FORT CALHOUN STATION, UNIT NO. 1

AMENDMENT TO FACILITY OPERATING LICENSE

Amendment No. 78
License No. DPR-40

ATTACHMENT TO LICENSE AMENDMENT NO. 78

FIGURE
5-2

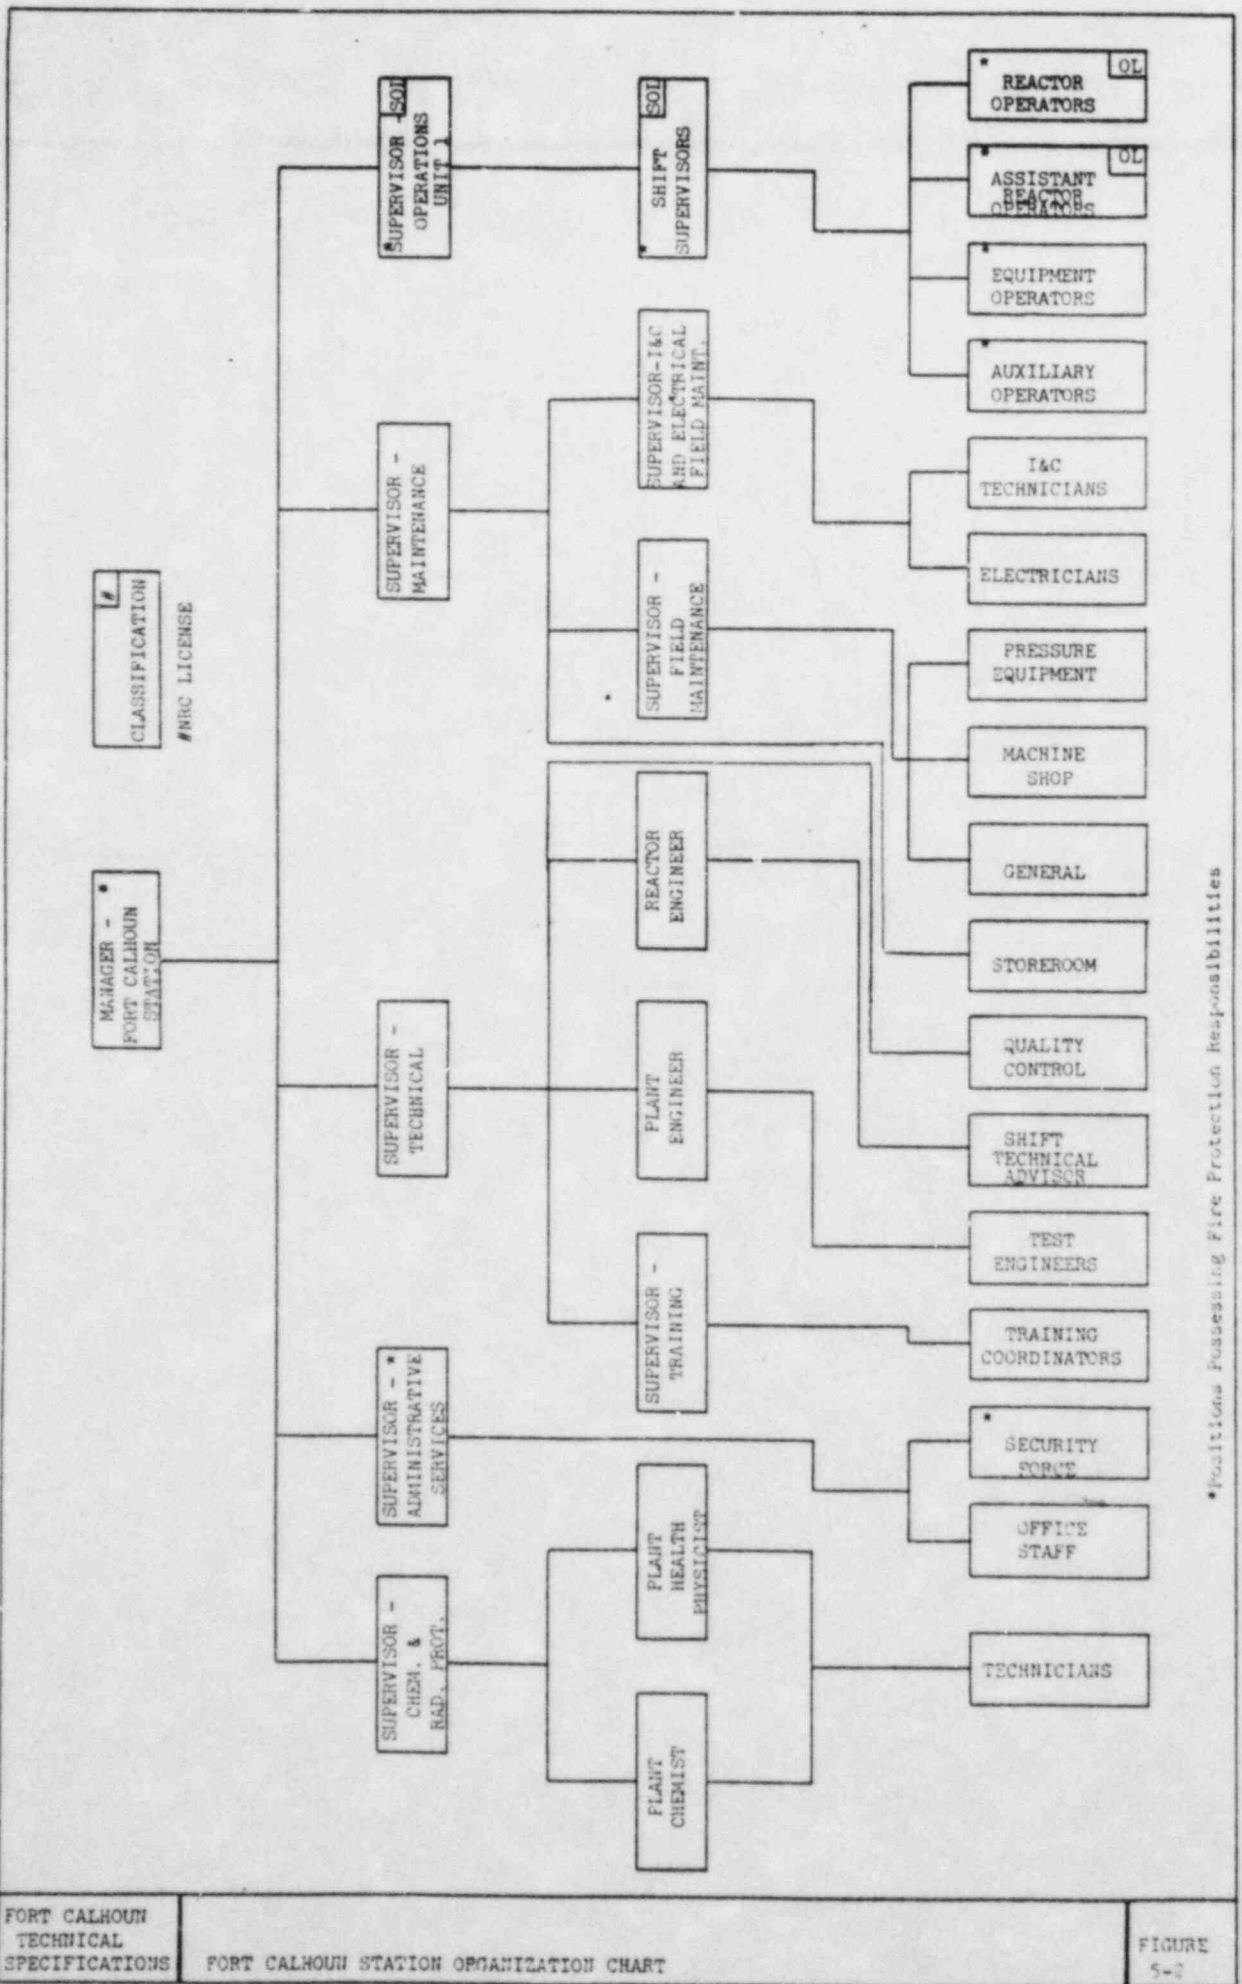
Revise Appendix "A" Technical Specifications as indicated below. The revised pages are identified by amendment number and contain vertical lines indicating the area of change.

- d. Fire protection program responsibilities are assigned to those positions and/or groups designated by asterisks in Figures 5-1 and 5-2 according to the procedures specified in Section 5.8 of the Technical Specifications.
